SUBJECT: SUMMARY OF MEETING WITH THE NUCLEAR ENERGY INSTITUTE (NEI) TO DISCUSS STAFF'S REQUEST FOR ADDITIONAL INFORMATION (RAI) ON ENVIRONMENTAL ASSISTED FATIGUE

**REQUEST FOR ADDITIONAL INFORMATION
FOR PROPOSED INTERIM STAFF GUIDANCE (ISG)
FOR FATIGUE ENVIRONMENTAL EFFECTS**

Discussion of Response to RAI on ISG-11

Question 1A

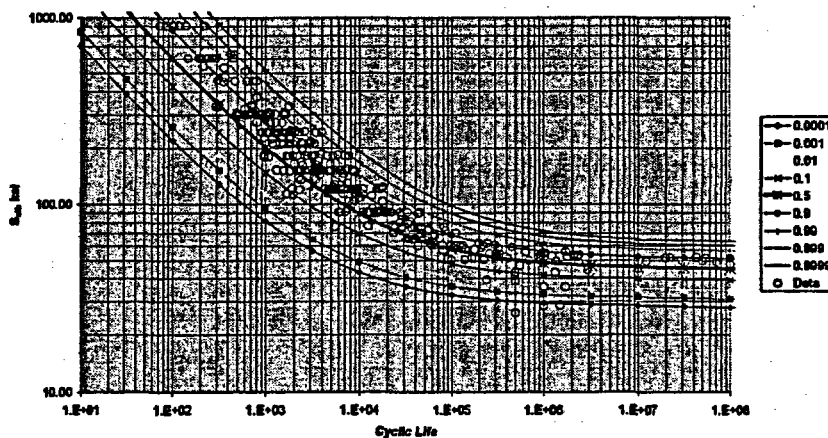
- *The revised probabilistic fatigue curves do not appear consistent with the data for carbon and low alloy steels. For example, compare probabilistic curves developed using the EPRI assumption for the standard deviation of the endurance limit with the data presented in Figure 14 of Attachment 1 of the submittal.*

- Most of data are above the mean curve
- Only a few points below the mean curve
- Detailed review of data shows low points resulted from high R-ratio testing
- Correction for mean stress effects shows that observed low points are within scatter band for remainder of data
- Therefore, the standard deviation chosen to represent the data is conservative

Mean Stress Adjustment

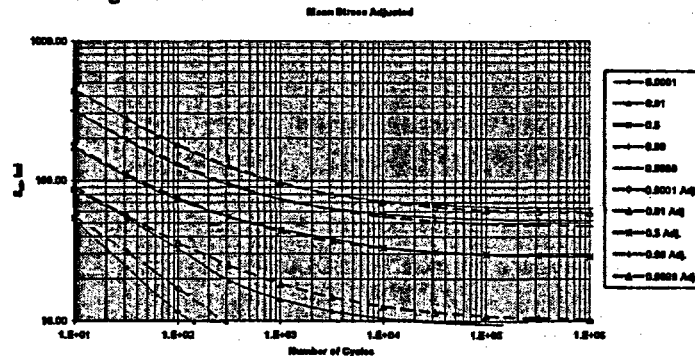
- The strain thresholds are discussed on page 26 of NUREG/CR-6717. NUREG/CR-6717 indicates that, after mean stress effects are taken into account, a threshold strain amplitude of 0.07% provides a 90% confidence level for both carbon and low alloy steels. As discussed previously, the threshold strain is approximately 20% higher than the endurance limit of the steel. Consequently, the 10 percent probabilistic fatigue curve should approach a strain amplitude of approximately 0.06% at 10E6 cycles. The 10 percent probability curve shown in Figure 3-11 of the EPRI report is not consistent with a strain of 0.06%. Discuss this discrepancy between Figure 3-11 of the EPRI report and the data assessment contained in NUREG/CR-6717.

- The EPRI report, page 3-11, provides a procedure to account for mean stress effects. Show how this procedure was implemented in the evaluations presented in Chapter 4 of the report. Discuss the consistency of the mean stress adjustment used in the Chapter 4 evaluations with the mean stress adjustment discussed in NUREG/CR-6717.

- Response
 - Approach used in MRP-74 provides a more rigorous approach for mean stress adjustment
- In NUREG/CR-6335 and -6717, a modified Goodman approach was used to adjust fatigue curves down; implemented in modified curve fit equations

- Both arrive at essentially the same results as shown on the following pages for $S_{uts} = 100 \text{ ksi}$ and $S_{ys} = 70 \text{ ksi}$

Response to Question 5

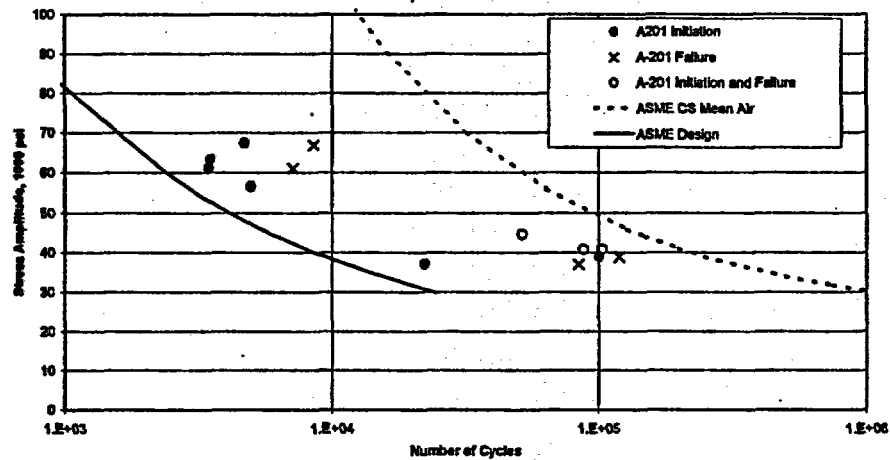
- The submittal references the evaluation of the component fatigue tests contained in EPRI Report MRP-49. The evaluation of the component fatigue test data is similar to the evaluation contained in EPRI Technical Report, "Guidelines for Addressing Fatigue Environmental Effects in a License Renewal Application (MRP-47)," Draft Revision G dated June 5, 2001. This report was submitted to the NRC by NEI letter dated July 31, 2001. The staff transmitted a request for additional information regarding the evaluation of the component fatigue tests by letter dated June 26, 2002. The staff has not received a response to its request for additional information. Indicate how the relevant June 26, 2002, staff comments have been addressed in the test data evaluation contained in EPRI Report MRP-49.

- The evaluation of component tests did not include the data from the Southwest Research Institute tests on vessels that is shown on page 4 of NUREG/CR-6583. This test data does not appear to support conclusion regarding the maximum effect of size and surface finish on fatigue life. Explain why this data was omitted from the evaluation. Provide an assessment of the Southwest Research Institute using the same method used to assess the KWU tube tests and the General Electric pipe tests.

- Appendix C of MRP-47 evaluated preliminary component-scale fatigue data with at least one surface in contact with oxygenated water at temperature
- MRP-49 included component-scale fatigue data with at least one surface in contact with oxygenated water at room temperature – the same PVRC/SWRI carbon and low-alloy steel pressure vessel fatigue data shown on page 4 of NUREG/CR-6583
- The evaluation process for these pressure vessel fatigue test data was identical to the process used to evaluate the KWU 180-degree bend fatigue tests and the General Electric pipe tests. The results for all three sets of component fatigue tests are completely consistent
